# SERVICE BULLETIN

M-1036

Safety Recall Code 083

## KIT NO. 91080-93 SOCKET HEAD SCREWS

Socket Head Screw Comparison

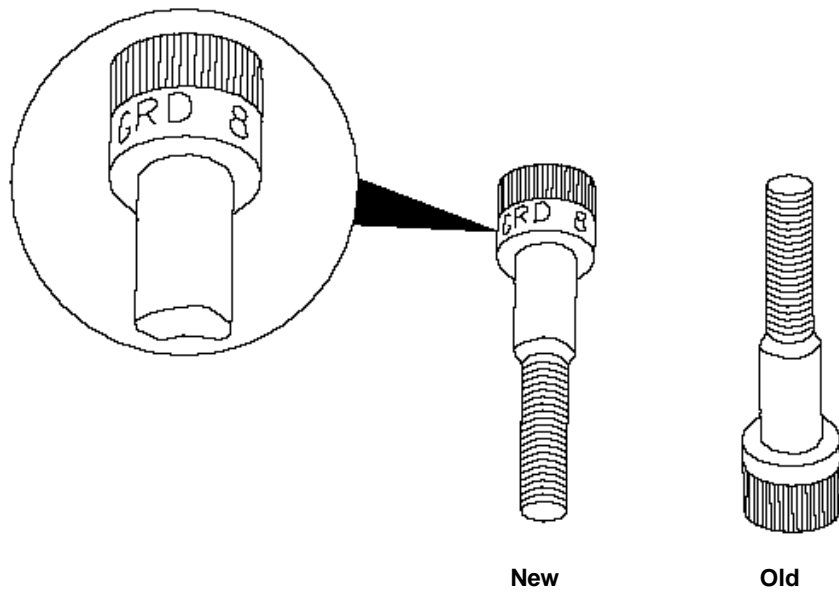
As stated in our August 12, 1993 Mailgram, ML-333, the Heritage chrome front fender rail kit, Part No. 91080-93 with a packaging date of 6/93, contains four (4) screws, Part No. 4326A, which could possibly break. If the screw(s) break, it could cause looseness of the fender and bumper. In some cases this may result in contact of these parts with the front tire.

Harley-Davidson is shipping 4 new 5/16-18 x 2 in. socket head screws and 4 new 5/16-18 nuts for each kit. The heads of these screws are marked "H-D GRD 8". The kit number for the screws and nuts is 93713.

1. Remove the 5/16-18 x 2 in. socket head screws and 5/16-18 nuts.

2. Install the new 5/16-18 x 2 in. socket head screws and 4 new 5/16-18 nuts

3. Tighten the screws to 14-18 ft-lbs torque.
